**Addendum #2
Anderson Public Library
Lapel Branch Green Space Renovation**

Date: May 24, 2024
Project: Anderson Public Library- Lapel Branch Green Space
Project #: 23006
Pages: 1 of 2 (8-1/2x11) pages
Bid Dates: **Wednesday, May 29, 2024 at 3:00 pm (prevailing local time)**

QCP SNAIL FOUNDATION

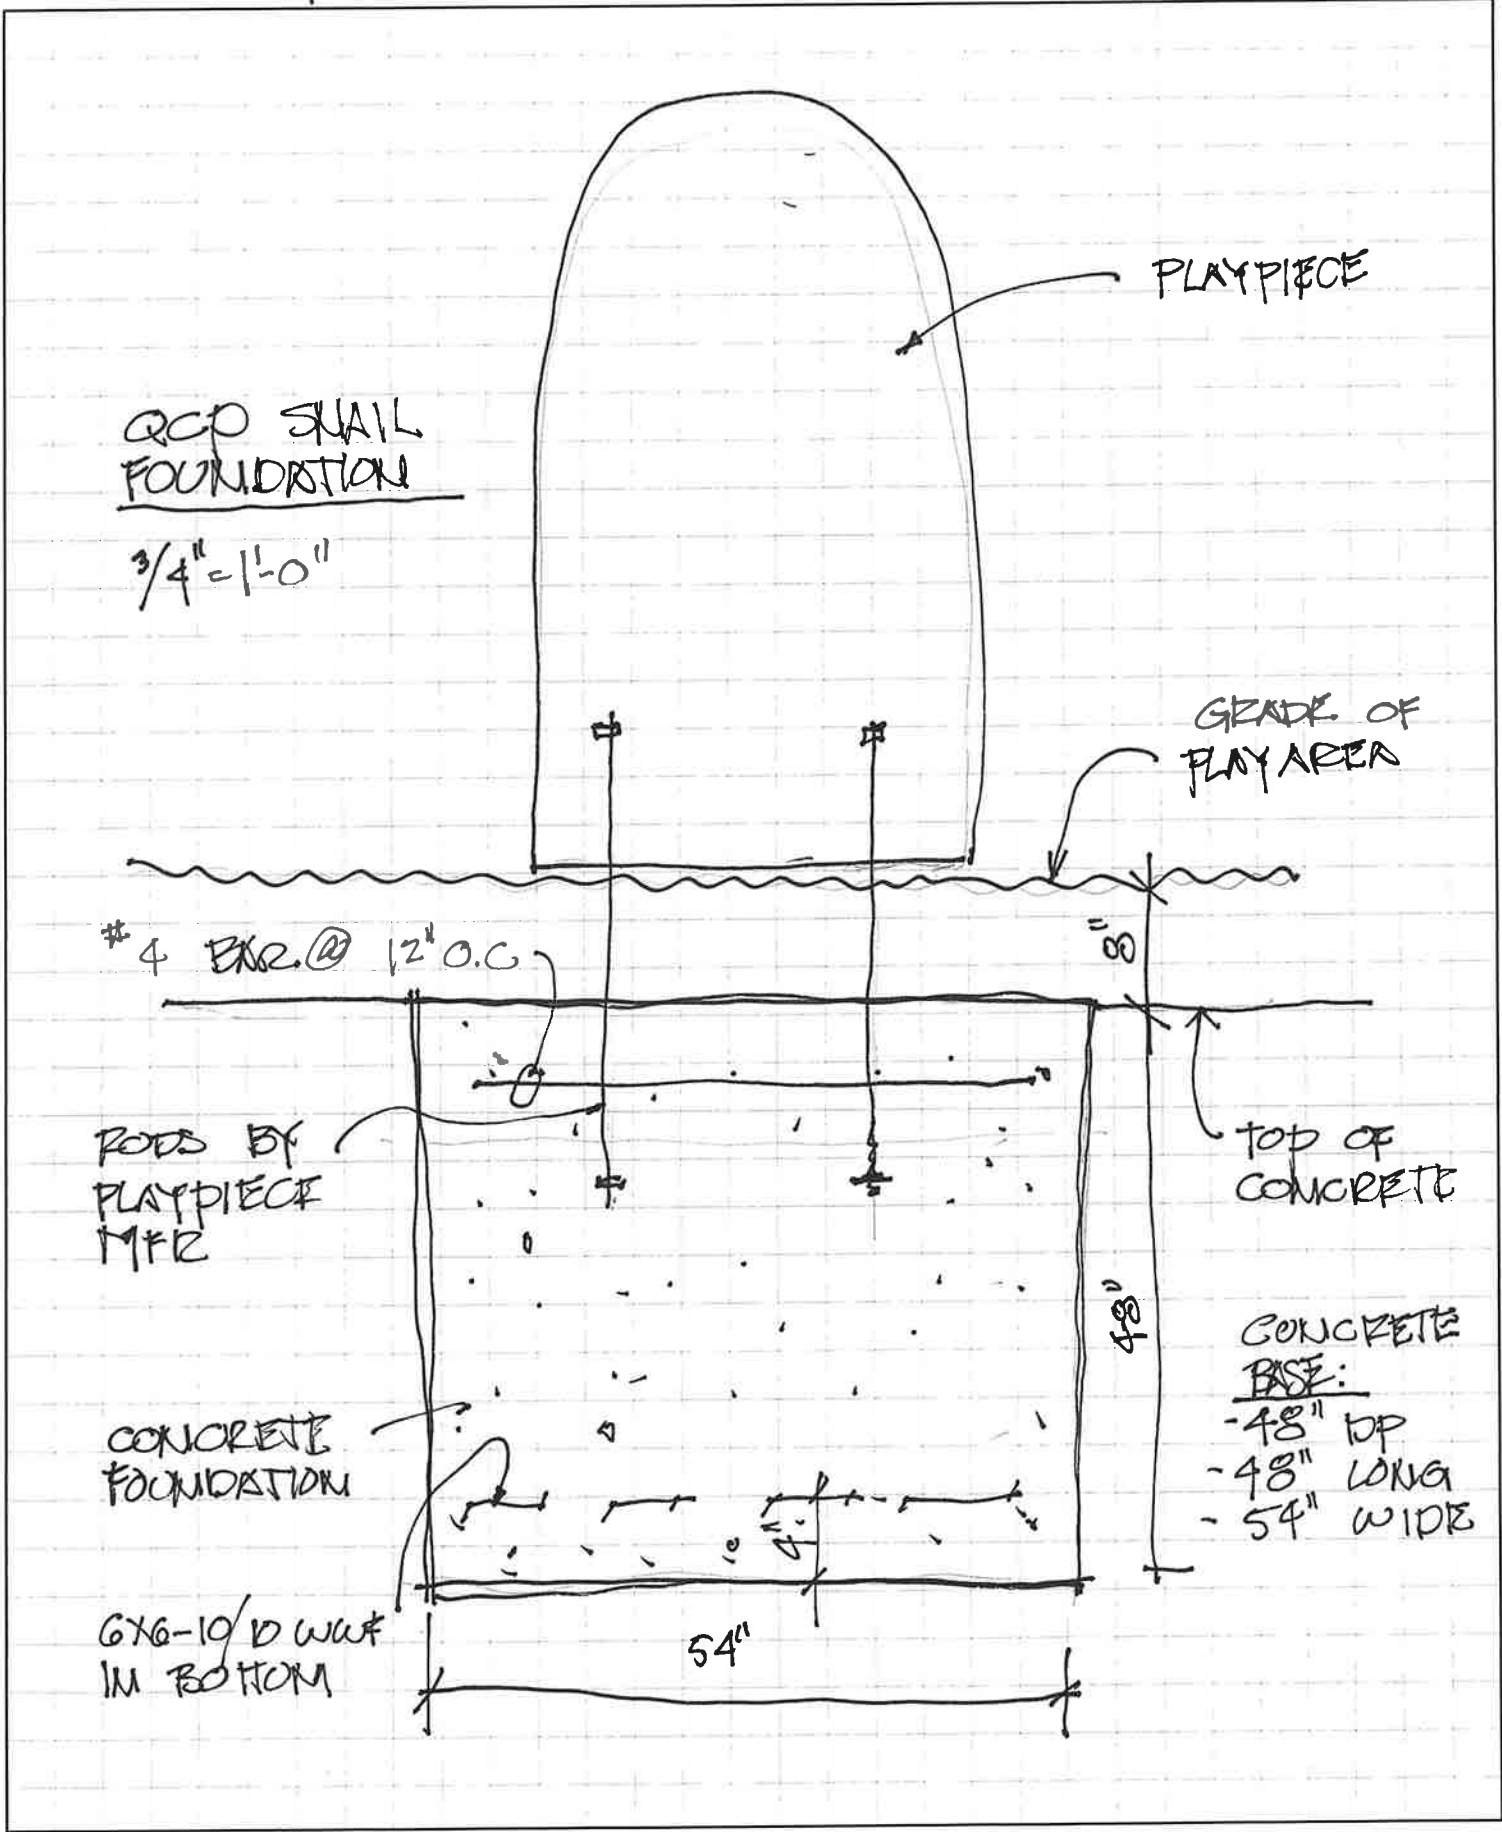
Q: The concrete play statue in Alternate #1 requires a footing to anchor the statue with 30” long coil rods. The manufacturer defers the design of this footing back to the Architect/Engineer, can you please provide dimensions and reinforcing for this footing?

A: Refer to footer detail attached to this Addendum.

#4 BAR @ 12" O.C.

CONCRETE BASE:
-48" HP
-48" LONG
-54" WIDE

6x6-10/D W/ #4 IN BOTTOM
